**CITY OF PLACERVILLE PLANNING COMMISSION
STAFF REPORT
JULY 17, 2018 REGULAR MEETING**

Subject: 3094 Cedar Ravine - Site Plan Review (SPR) 98-07-R (Master Sign Plan Amendment) – Cedar Professional Building: Request to replace an existing non-illuminated ground sign for the professional office building use, approved under SPR 98-07 in 1998.

D/F Monument Sign

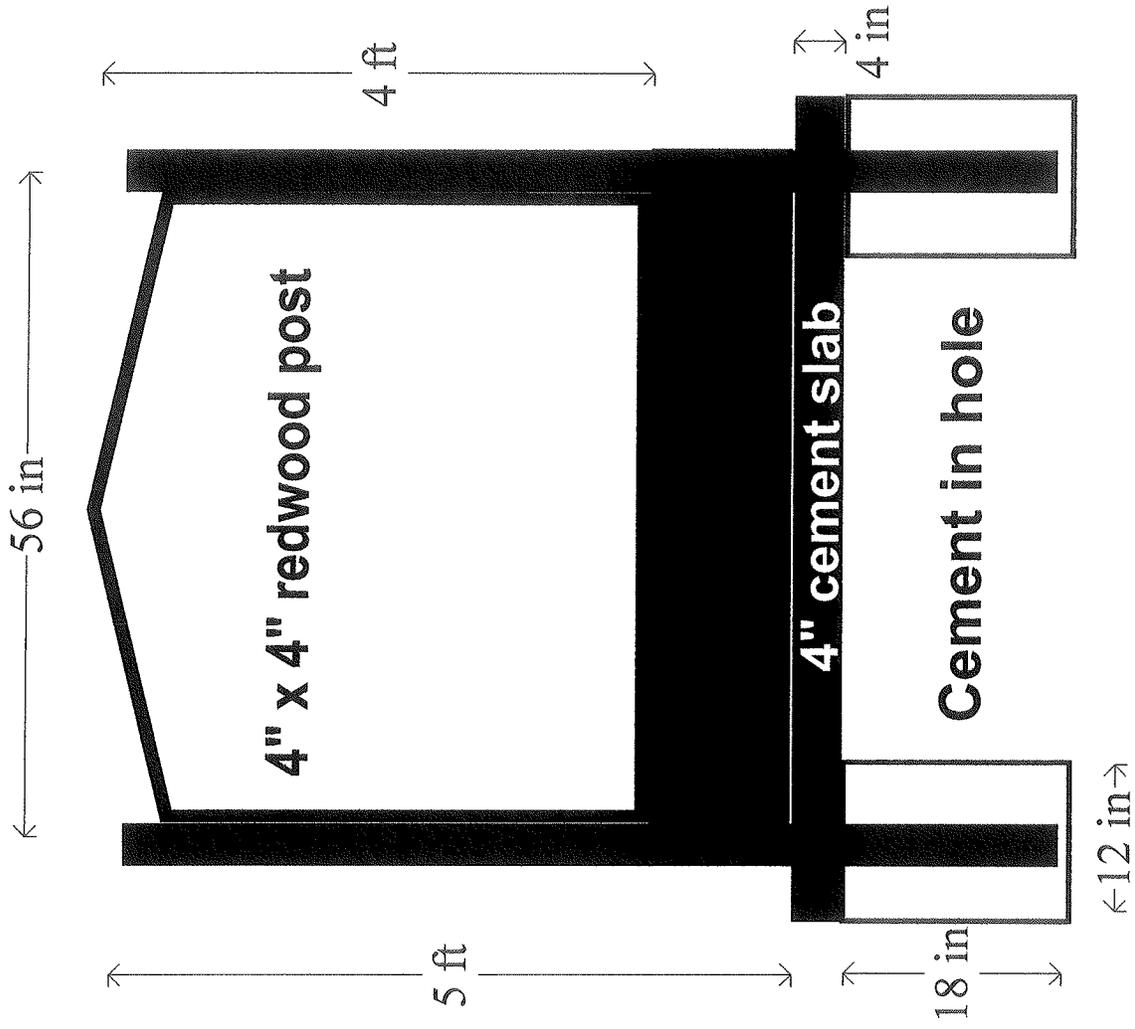
New sign structure architecture utilizes a framework of vertical sides and angled top that resembles a roof gable. This is similar to, and compliments, the appearance of the professional office building's exterior walls and gabled architecture. Sign scale appears adequate for tenant and address identification. Proposed sign materials are durable and were chosen to closely resemble those of the office building. Colors chosen would further match those of the office building. The ground sign meets Site Plan Review design criteria.

Sign structural support posts are covered at one hundred percent of the overall fifty-six inch sign width. Sign area is 19.2 square feet. Overall sign height is five feet four inches. Sign and sign structure comply with the requirements and criteria for ground signs.

Cedar Professional

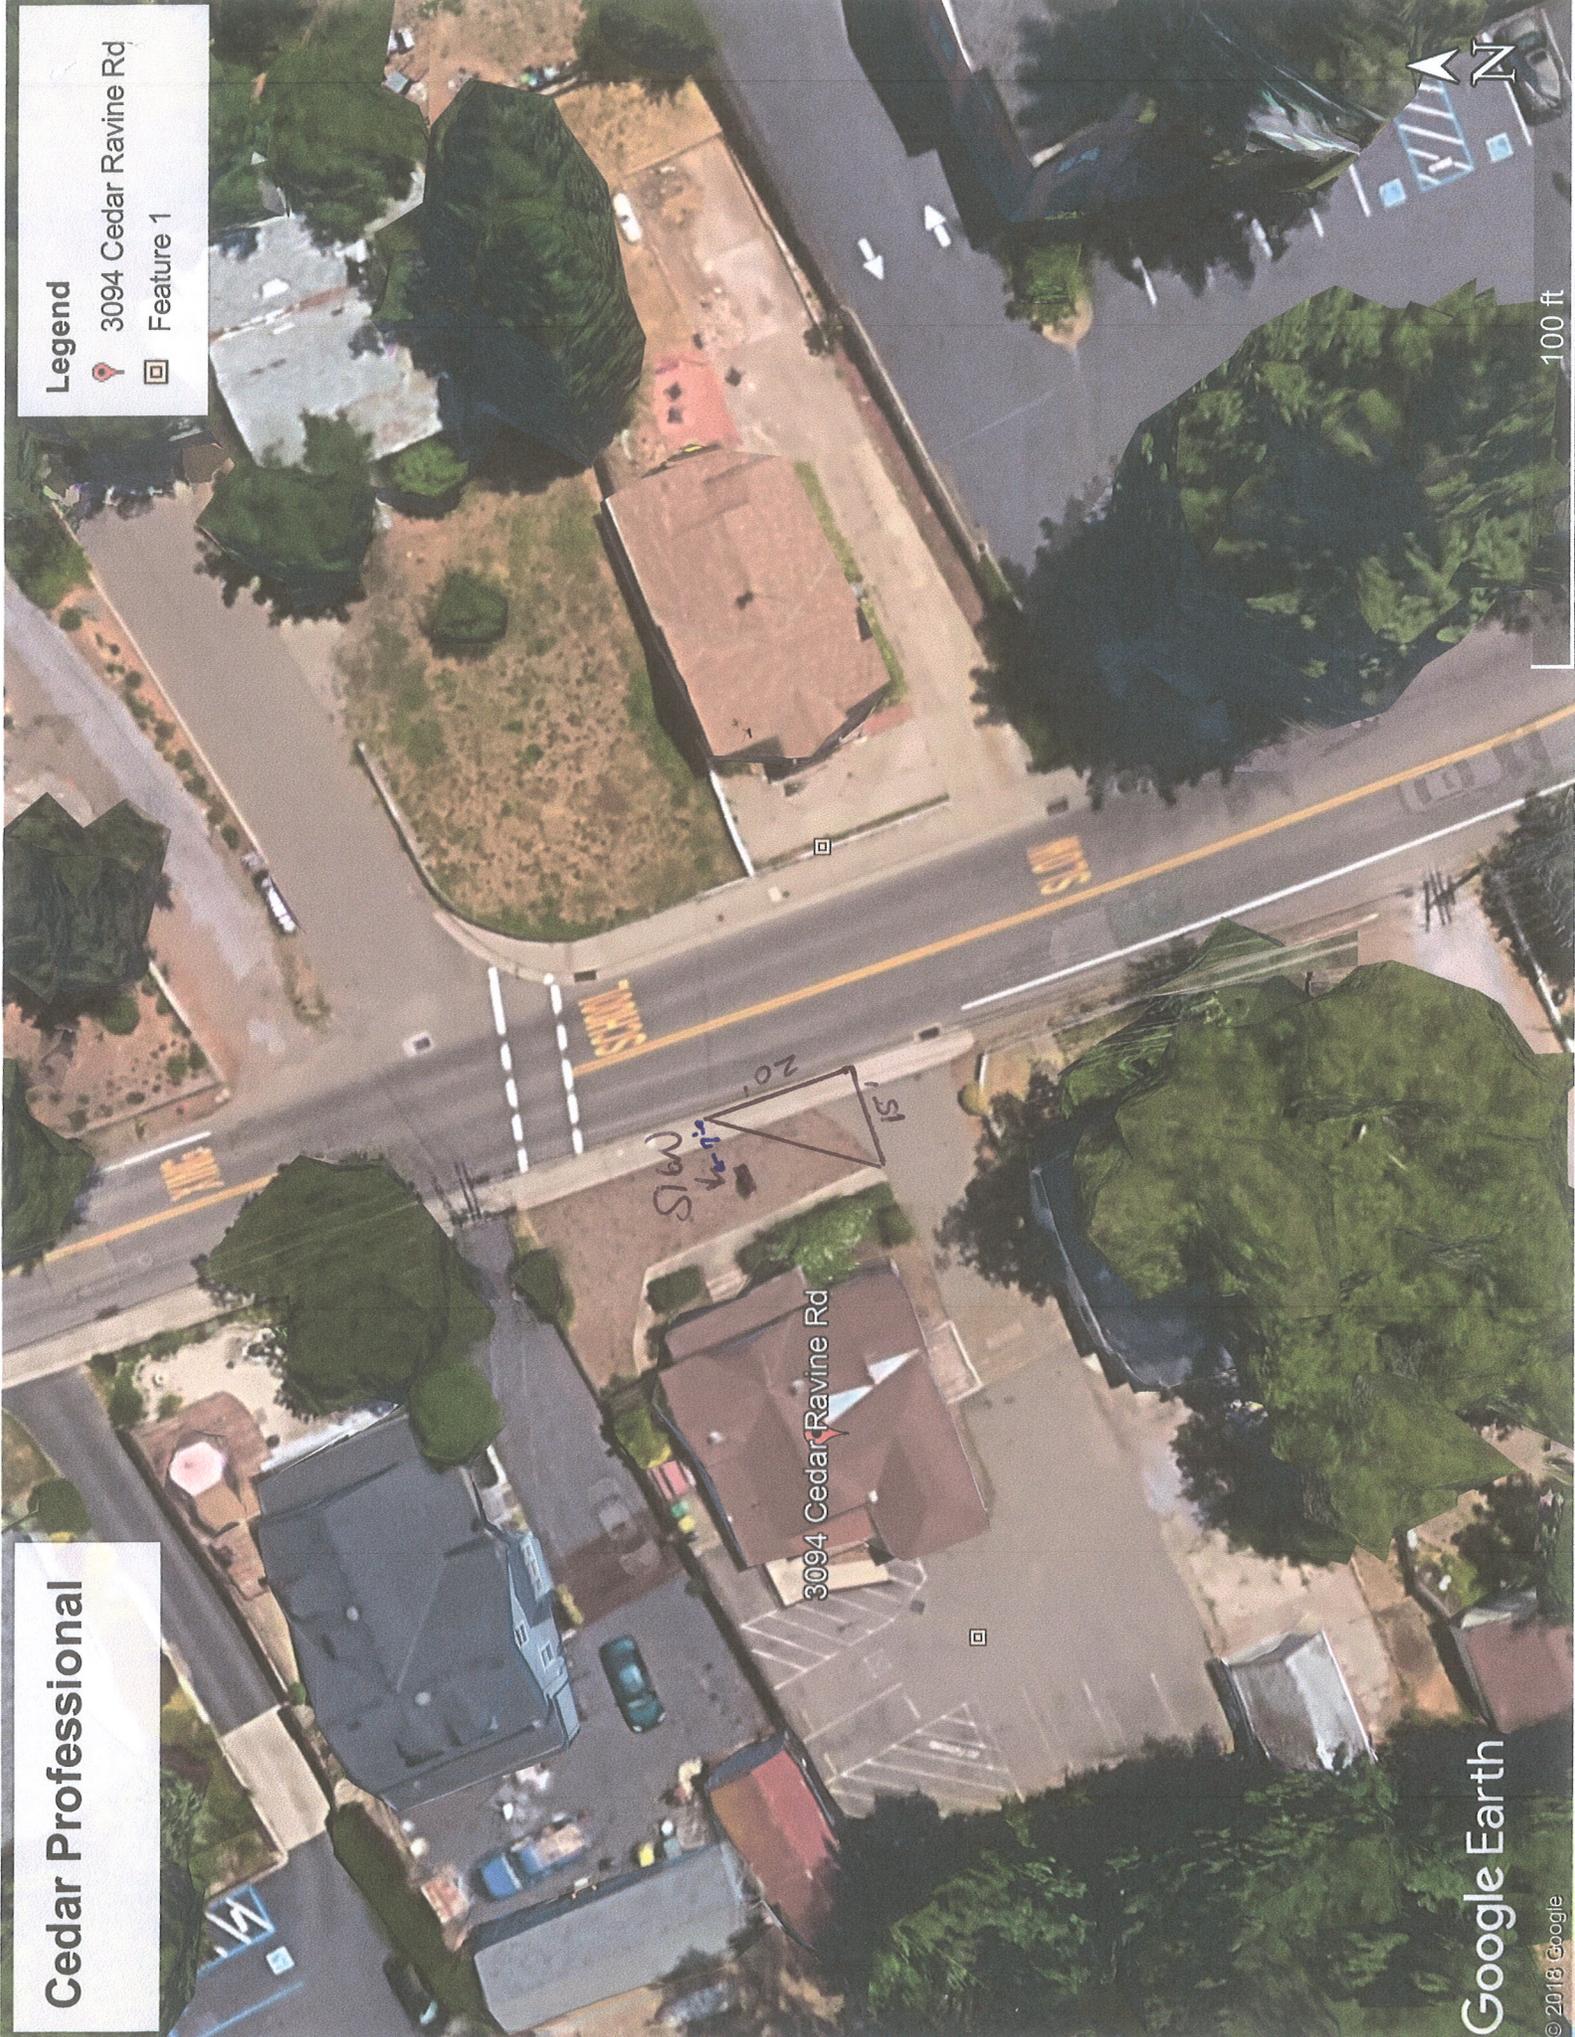
A visit to the site on June 28, 2018 revealed that landscape gravel makes up most of the front yard. There were no Oregon Boxwood shrubs evident within the front yard. The site is not landscaped as approved under SPR 98-07. The Commission could condition this Major Change to SPR 98-07-R as follows to correct this issue:

1. Require the front yard to be landscaped within six month of approval of the Master Sign Plan, as shown in the 1998 approved landscape plan for SPR 98-07, subject to inspection by the Development Services Department.
2. The property owner shall record a Landscaping Maintenance Agreement in accordance with City Code Section 10-4-9: Site Plan Review prior to final inspection by the Development Services Department of front yard landscaping.

- 7 The front yard is to be landscaped within six month of approval of the Master Sign Plan, as shown in the 1998 approved landscape and irrigation plan for SPR 98-07, subject to inspection by the Development Services Department.
8. The property owner shall record a Landscaping Maintenance Agreement in accordance with City Code Section 10-4-9: Site Plan Review prior to final inspection approval by the Development Services Department of front yard landscaping and irrigation.
